**Commonwealth Edison**  
 One First National Plaza, Chicago, Illinois  
 Address Reply to: Post Office Box 767  
 Chicago, Illinois 60690

Subject: Reactor Containment Leakage Testing for the  
 Dresden and Quad-Cities Reactors, AEC Dkts  
 50-237, 50-249, 50-254 and 50-265

In response to your letter dated August 9, 1973, the following information is provided concerning the applicability of 10 CFR 50, Appendix J to containment leakage testing at Dresden and Quad-Cities. The numbering of the following responses corresponds to the numbering of requests in your August 9, 1973 letter.

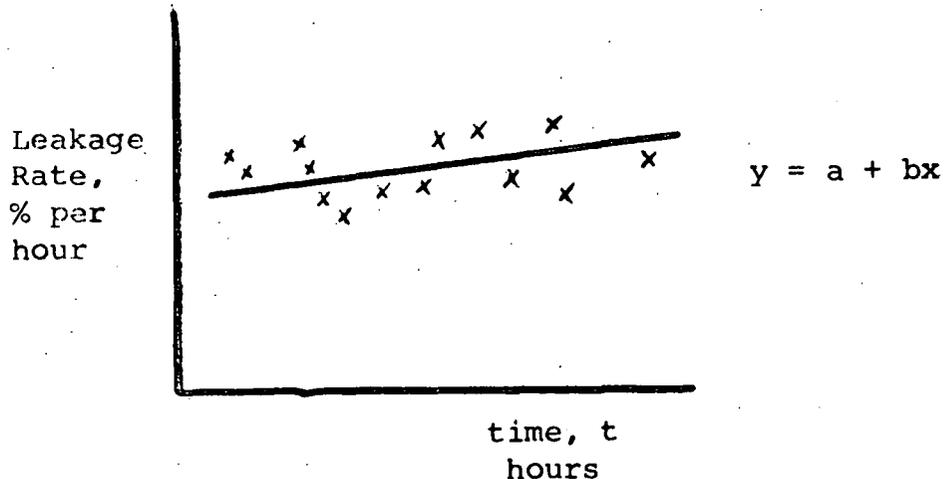
We feel that the use of a least-squares fit to the data to obtain an averaged hourly leakage rate is somewhat misleading. The method of least-squares says that, given a set of data, the line  $y = a + bx$  will be the best "fit" to the data providing that the sum of the squares of the distance of each data point from the line is a minimum.

IPCLT data is a set of hourly leakage rates corresponding to specific times. For a leak rate line,  $y = a + bx$ ,  $b$  should be close to zero because the leak rate should theoretically be constant. This would result in  $y = a$  where "a" is a constant corresponding to the "statistically averaged hourly leakage rate." In reality, however, "b" will not be zero and the data fit will result in a line,  $y = a + bx$ , with a definite slope of "b". For example, using the least-squares fit could result in a

graph which looks like this:

Thus the only thing accomplished is a transfer of data points to a line. We still are faced with the problem of determining an average hourly leak rate. The uncertainty calculation, on the other hand, seems quite adequate, and we feel meaningful.
